Access Compliance Report Public Rights-of-Way (Pedestrian Signals)

Main Street: UNIVERSITY_DR Cross Street: IRVINE_AVE Location: N

ADA ID: SGRK211018114837 Signal Type: One Push Button-Non APS Overall Compliance: No Severity Scores: BTN 1: 10 BTN 2: N/A No BTN: N/A

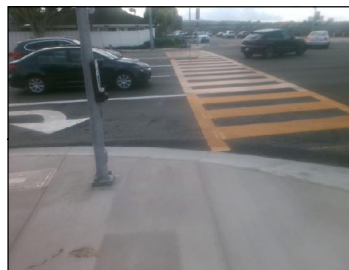
Surveyor Notes: Button 2 for Bike Lane

OC Std/PROW: MUTCD 4e.08

Possible Solutions: Replace Signal Push Button With APS Button. Remove & Relocate Sign.
